**V2500-A5/D5 SERIES PROPULSION SYSTEMS SERVICE BULLETIN**

This document transmits Revision 2 to Service Bulletin EV2500-72-0186

**V2500-ENG-72-0186**

MODIFICATION SERVICE BULLETIN – ENGINE – HP COMPRESSOR – NEW VARIABLE INLET GUIDE VANES AND STAGE 3 AND STAGE 4 VARIABLE STATOR VANES WITH INCREASED ANGULAR MOVEMENT

Location of VIGV's  
Figure 1

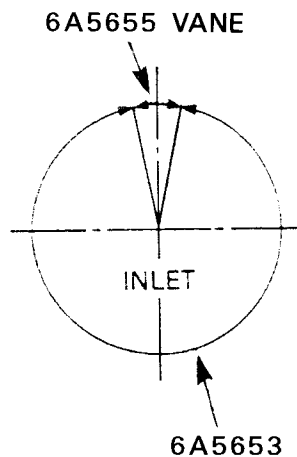
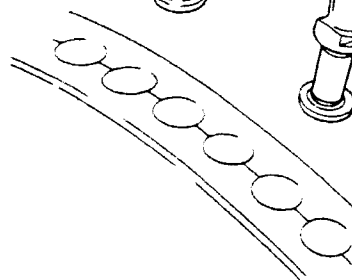
REMOVE 6A4201 VANE  
INSTALL 6A5653 VANE

REMOVE 6A4203 VANE  
INSTALL 6A5655 VANE

Rework of VIGV's and Stage 3 VSV's  
Figure 5

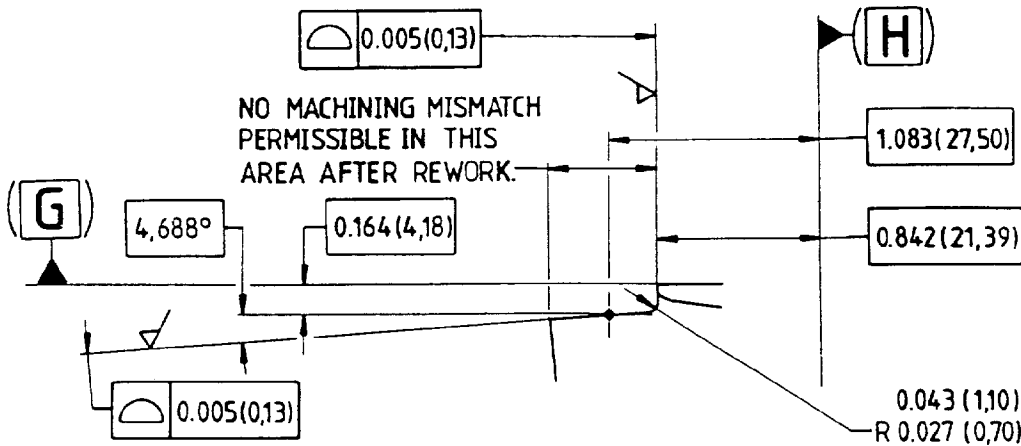
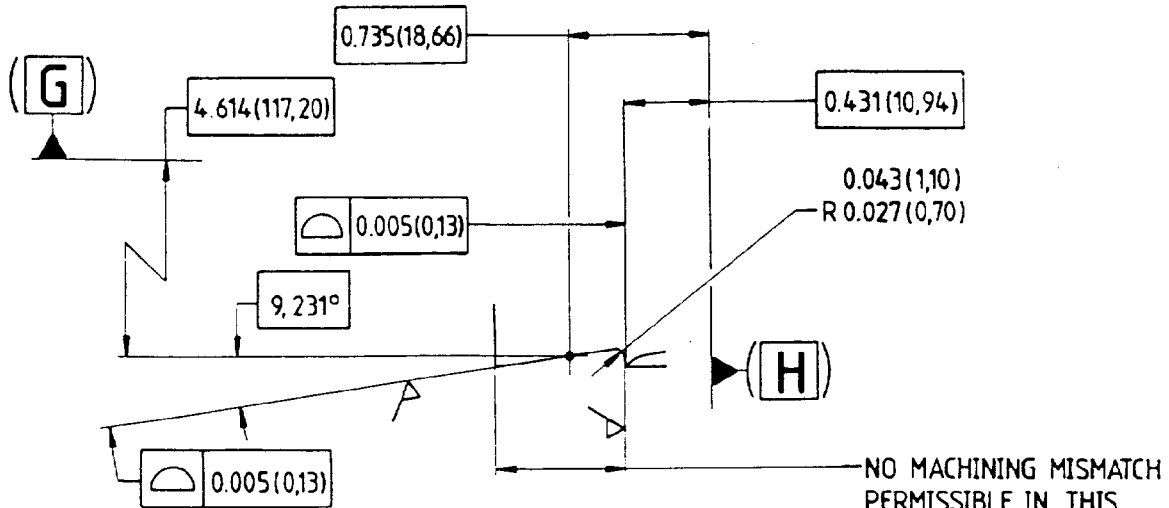
ENLARGED VIEW AT A (SEE FIG.4.)  
SHOWING REQUIRED REWORK OF  
EXISTING V.I.G.V.'S.

ENLARGED VIEW AT D (SEE FIG.2.)  
SHOWING REQUIRED REWORK OF  
EXISTING STAGE.3. STATOR VANES

0.020 (0,50)  
BREAK SHARP EDGES 0.004 (0,10).  
SURFACE FINISH TO BE 125(3,2) ✓  
U.O.S.

Rework Stage 3 VSV's  
Figure 6

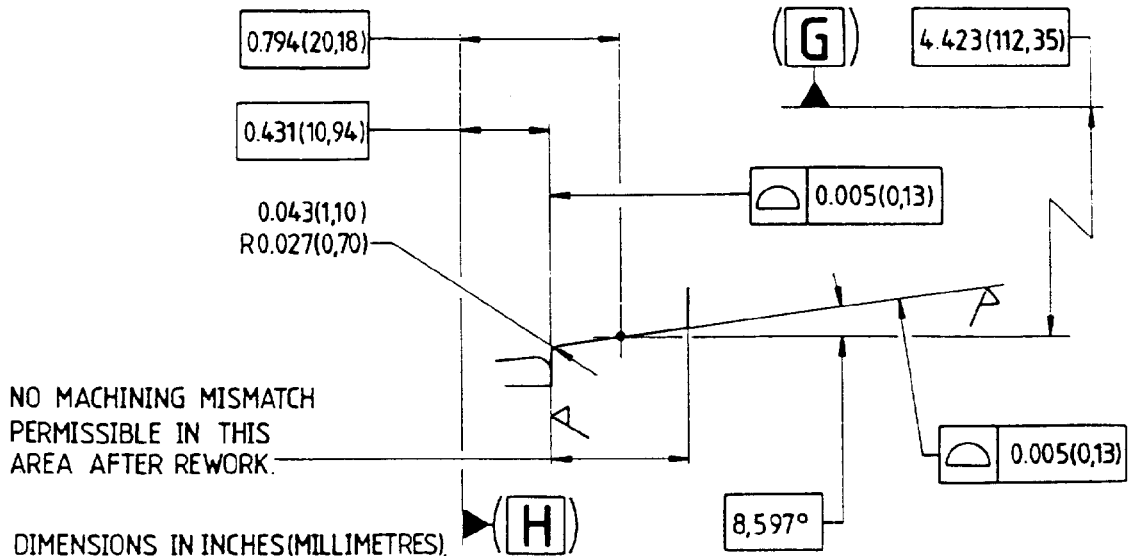
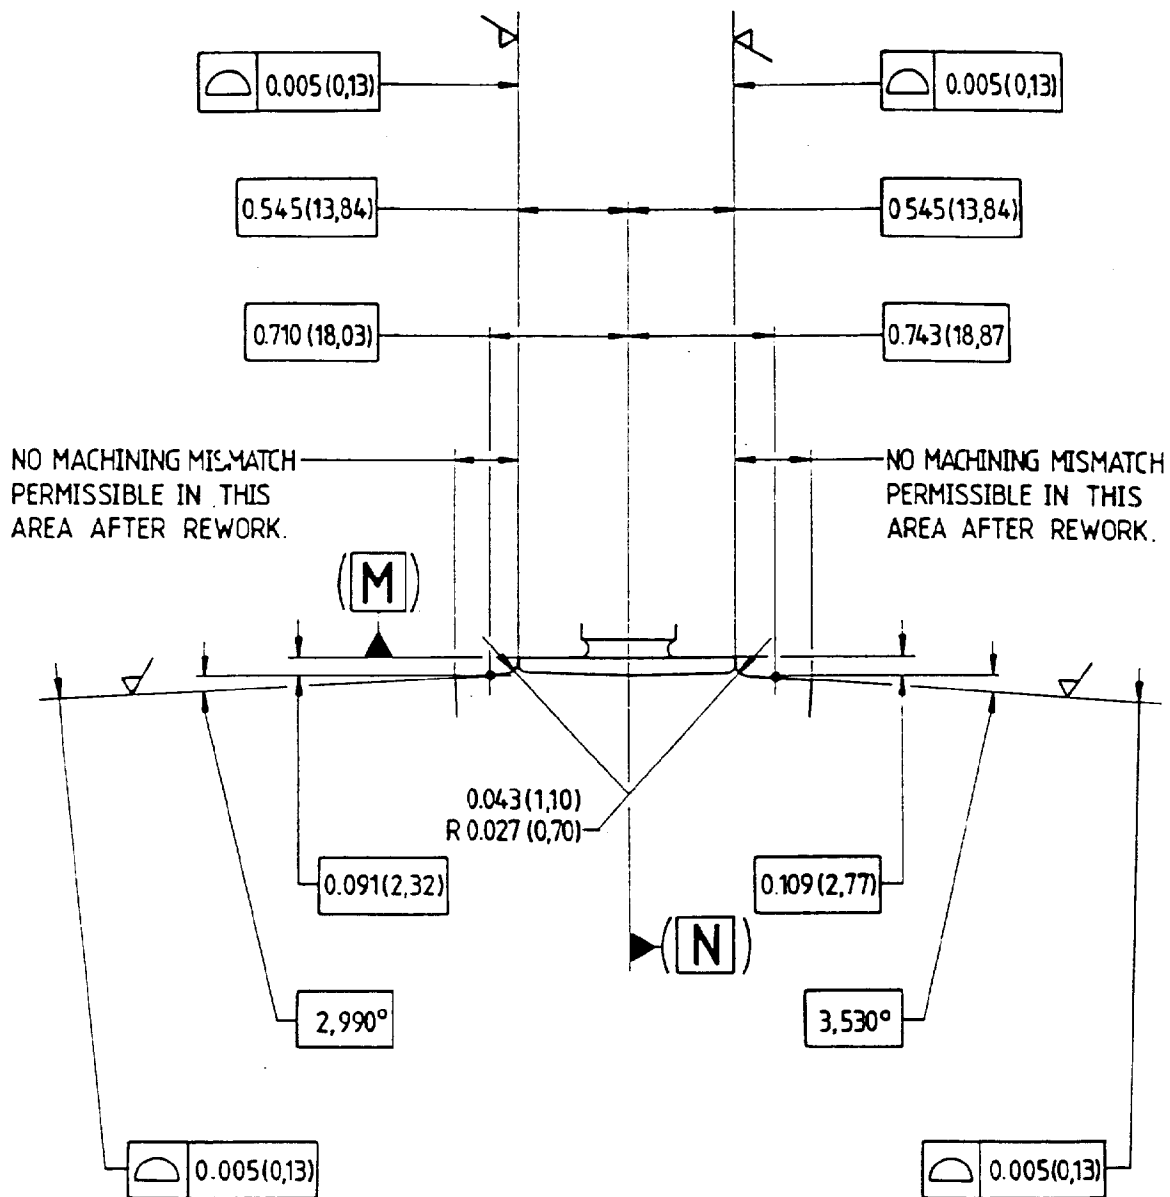
ENLARGED VIEW AT E (SEE FIG.4.)  
SHOWING REQUIRED REWORK OF  
EXISTING STAGE.3. STATOR VANES.

ENLARGED VIEW AT F (SEE FIG.4.)  
SHOWING REQUIRED REWORK OF  
EXISTING STAGE.3. STATOR VANES.

BREAK SHARP EDGES 0.020(0,50)  
0.004(0,10)

SURFACE FINISH TO BE 125(3,2) U.O.S.

Rework Stage 4 VSV's  
Figure 7 Sheet 2

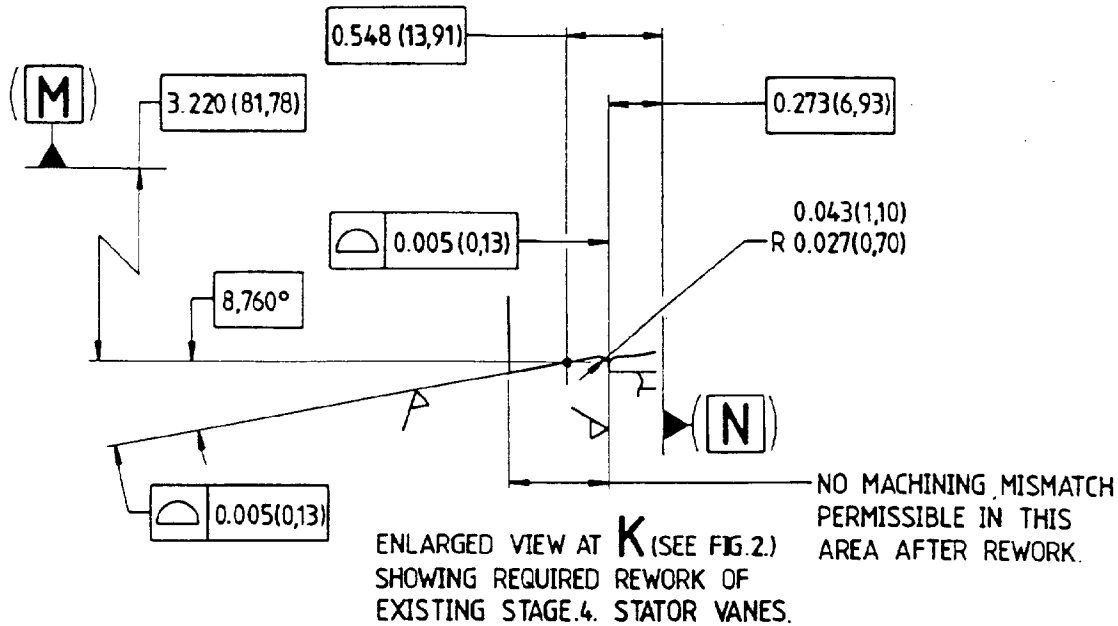
0.020(0,50)  
BREAK SHARP EDGES 0.004(0,10) ENLARGED VIEW AT L (SEE FIG.2.)  
SURFACE FINISH TO BE 125(3,2) SHOWING REQUIRED REWORK OF  
U.O.S. EXISTING STAGE.4. STATOR VANES.
